TSB150156

Turbocharger Coolant Hose Malfunction Caused by Hose Clamp

Figure 1, Damage to Turbocharger Coolant Hose and Suspect Hose Clamp

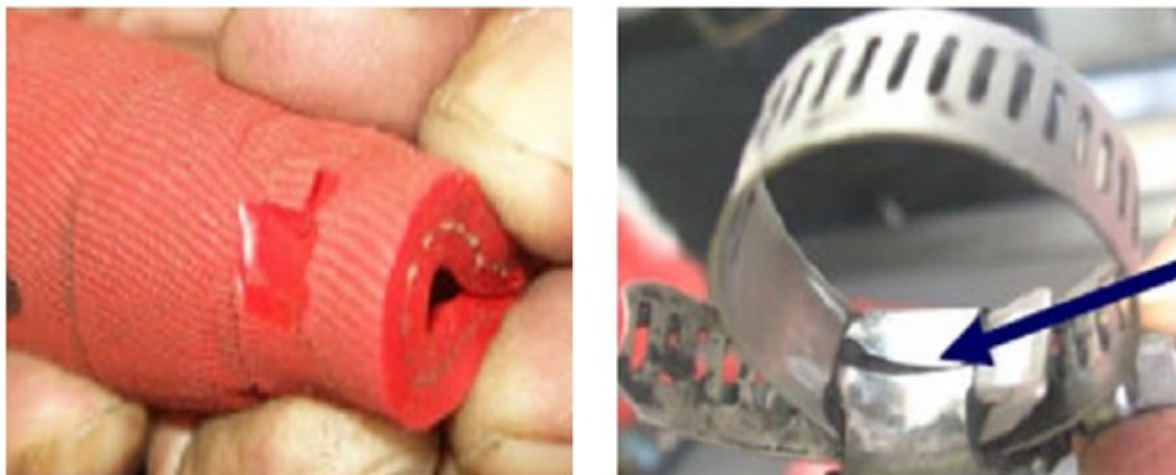
The turbocharger coolant hose can leak as the result of damage caused by a hose clamp.

If the turbocharger coolant hose is leaking coolant, inspect the hose clamp installation area of the turbocharger coolant hose for damage. See Figure 1 below for an example of damage.

Replace the damaged turbocharger coolant hose. When installing the new turbocharger coolant hose use spring hose clamp, Part Number 5267079, instead of hose clamp, Part Number 3820672 or Part Number 5316194.
